Road & Bridge Design Publications

Monthly Update – March 2016

Revisions for the month of **March** are listed and displayed below. New special details will be included in projects submitted for the **June** letting as is stated on the special detail index sheets. E-mail Road related questions on these changes to MDOT-Road-Design-Standards@michigan.gov. E-mail Bridge related questions to MDOT-Bridge-Design-Standards@michigan.gov.

SPECIAL DETAIL 21

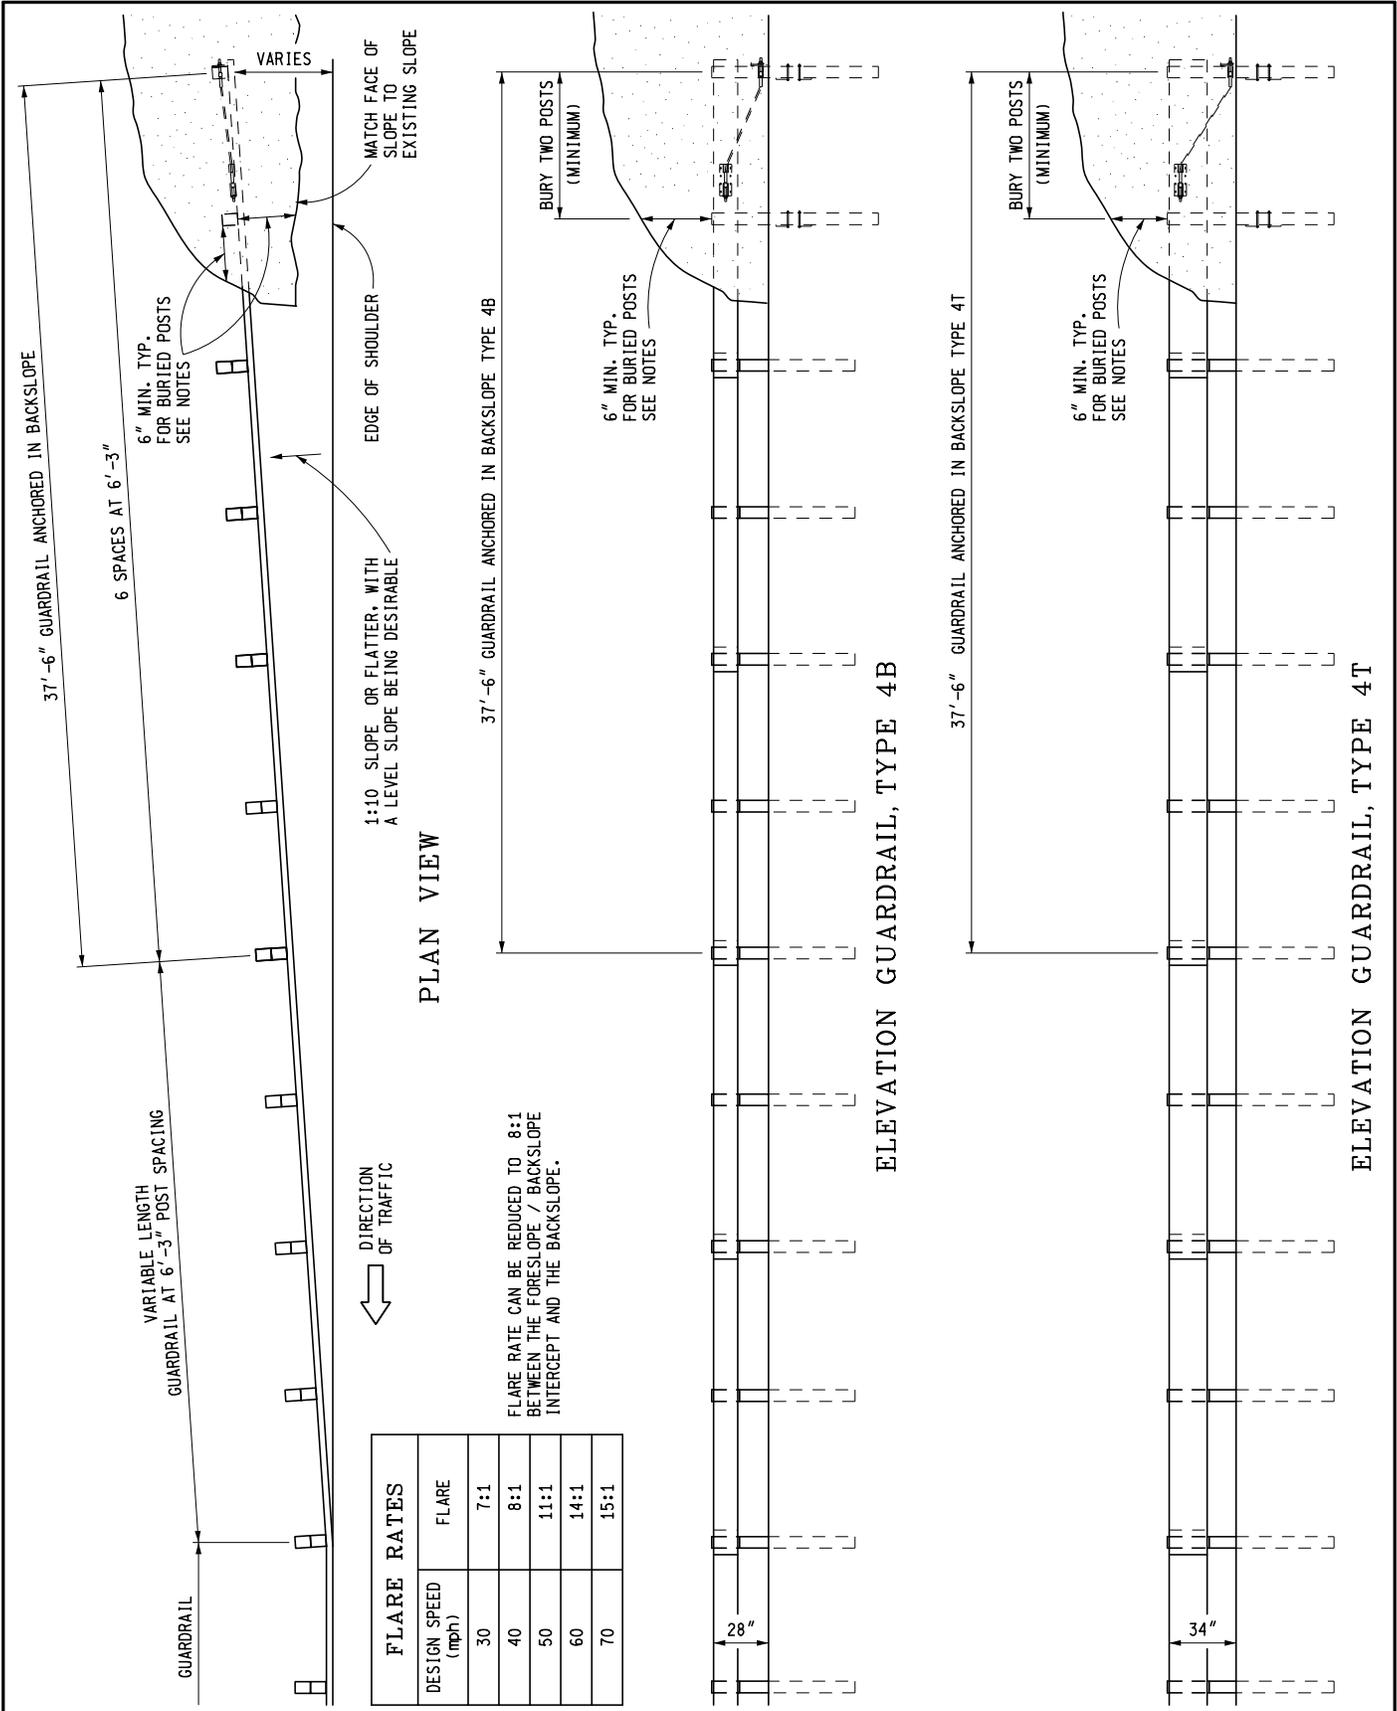
21: Guardrail at Intersections: Revised the detail on sheet one to allow the use of MGS Guardrail along the trunkline portion of the roadway.

F.H.W.A. APPROVAL	3-14-2016 PLAN DATE	SPECIAL DETAIL 24	SHEET 2 OF 8
-------------------	------------------------	-------------------	--------------

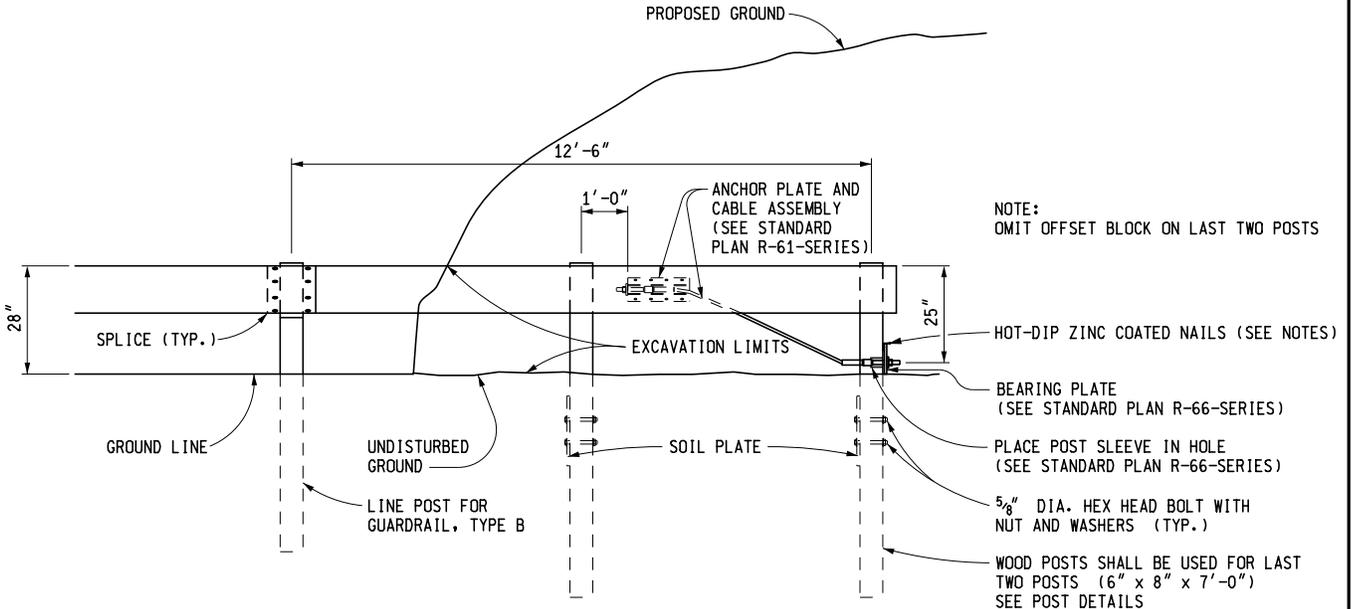
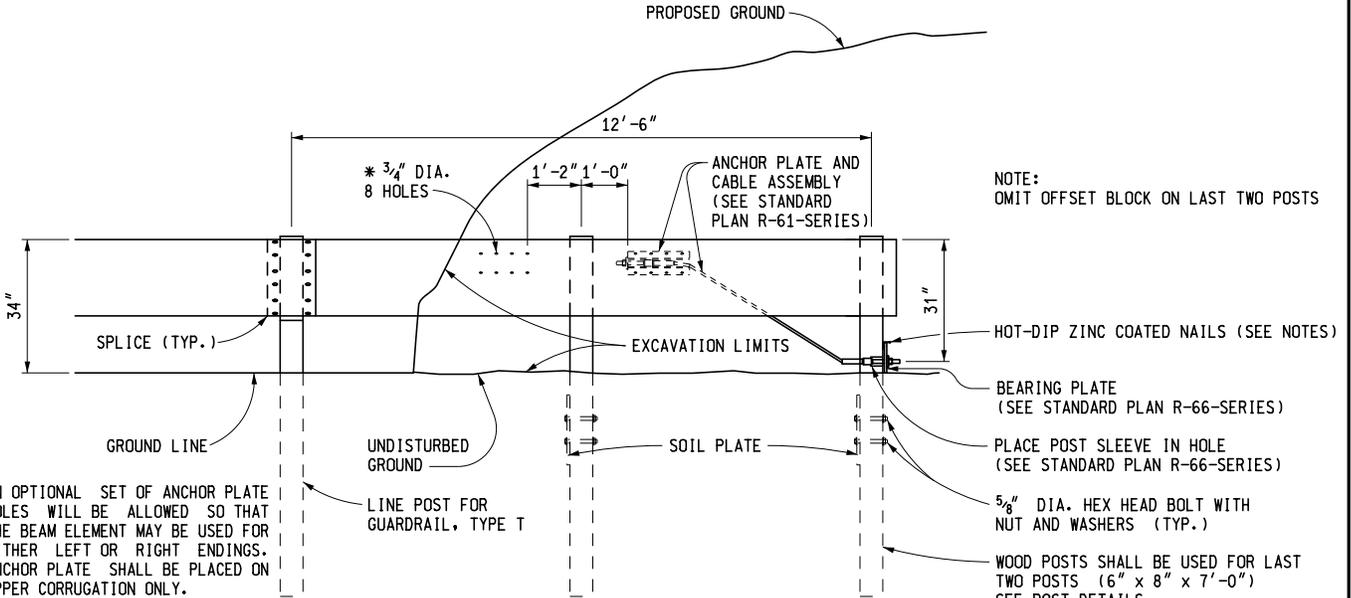
24: Guardrail Anchored in Back Slope Types 4B, 4T, & 4MGS-8: Added details for MGS guardrail on sheets 2, 4, & 7.

GUARDRAIL LONG SPAN, DETAIL MGS-1

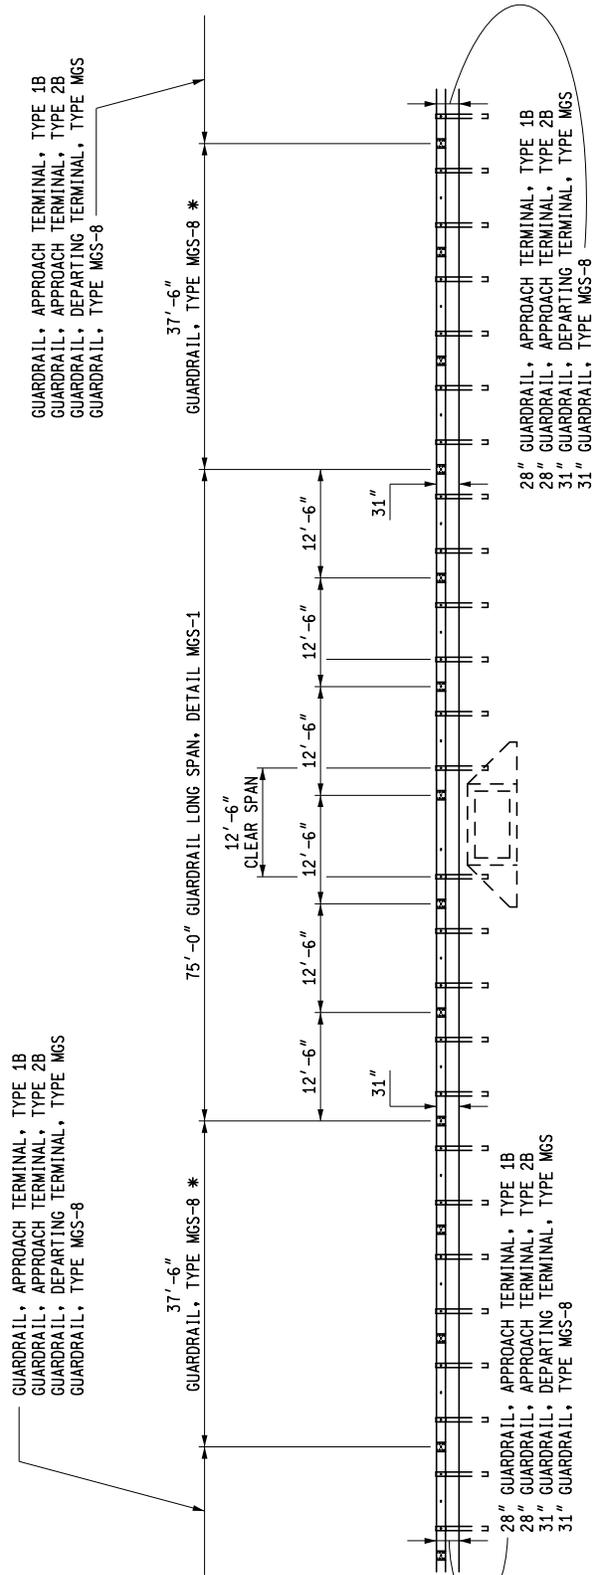
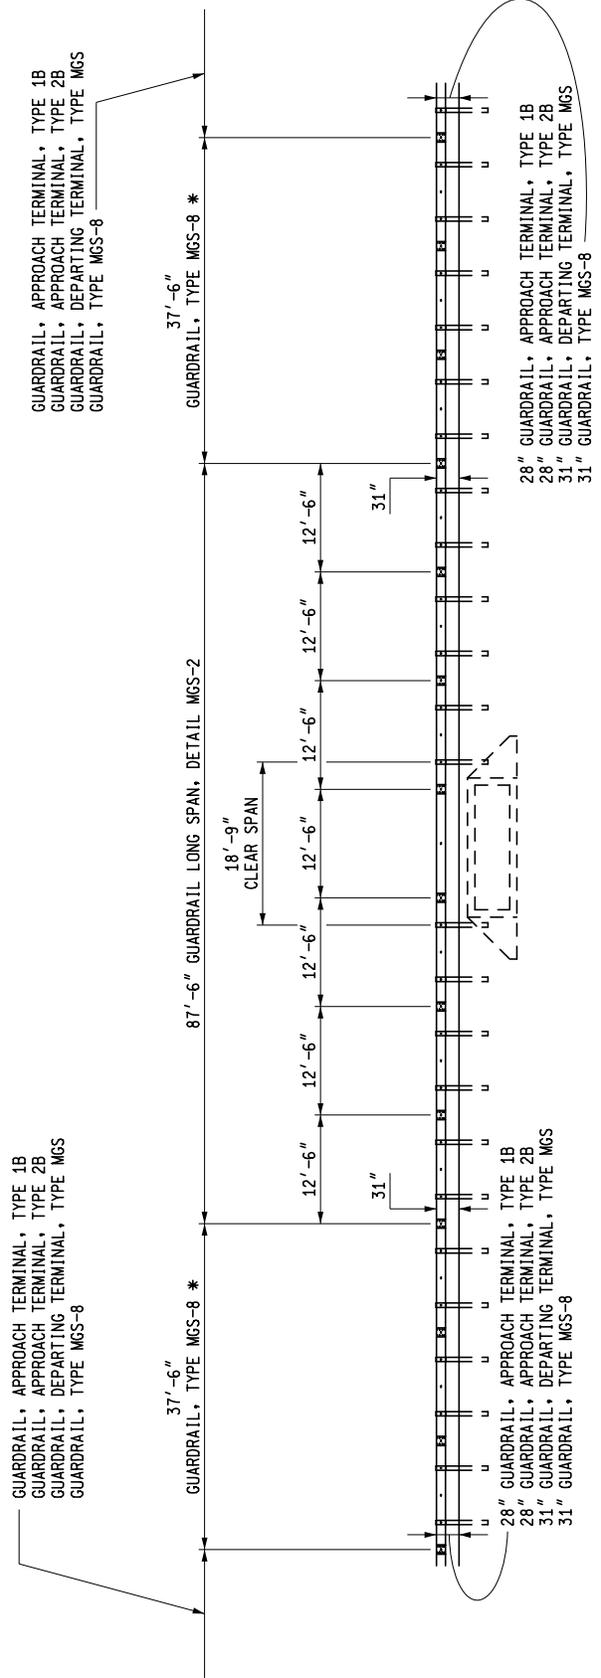
R-72-D: W-Beam Backed Guardrail & Guardrail Long Span Installations: Added details for three long span installations over culverts using MGS guardrail. Also, added a long span installation using Type B guardrail.
